## **ADDITIONAL INFORMATION**

### **DA2020/0053 for Alterations and additions to a dwelling house and construction of an attached dual occupancy at 141 Powderworks Road, Elanora Heights**

**Proposed car parking arrangement**

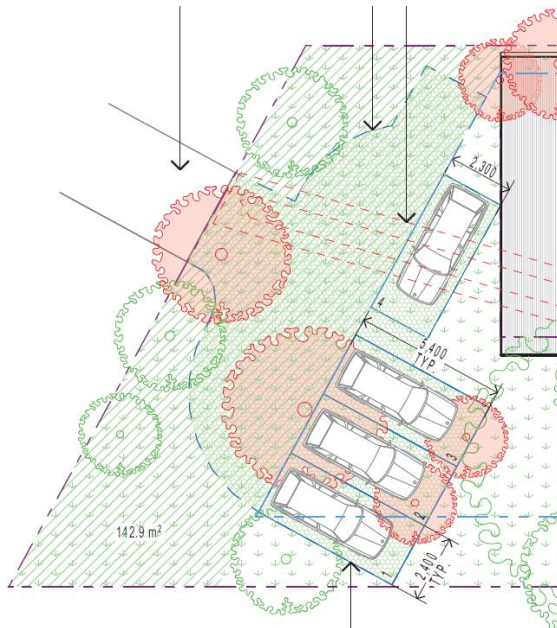
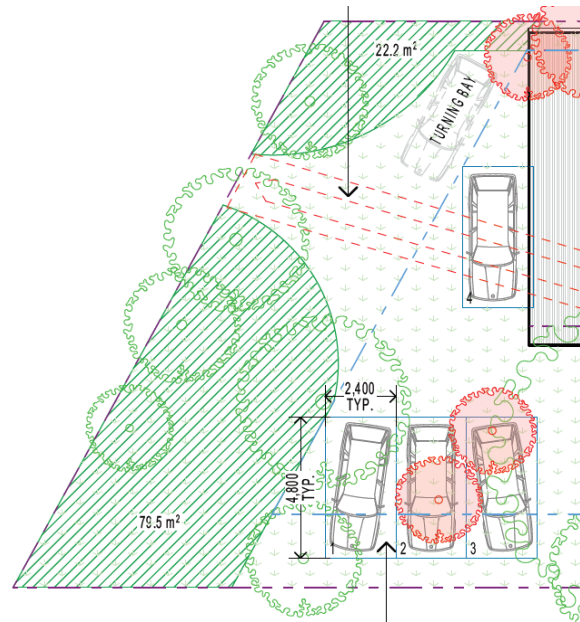
The revised design to achieve compliant car parking has resulted in a reconfiguration of the proposed on-site car parking spaces. This has resulted in a modest reduction in the proposed development's Landscaped area.

The site area is 1017.5 29m<sup>2</sup> generating a Landscaped Area requirement of 610.5m<sup>2</sup>. The proposal provides for 564.1m<sup>2</sup> / 55.4% of Landscaped Area, excluding the proposed driveway manoeuvring and car parking areas. This represents a variation to the control of 46.4m<sup>2</sup> or 7.6%. This variation is acknowledged and justification is provided below having regard to the circumstances of the case, merits of the design, and in response to the objectives of the planning control.
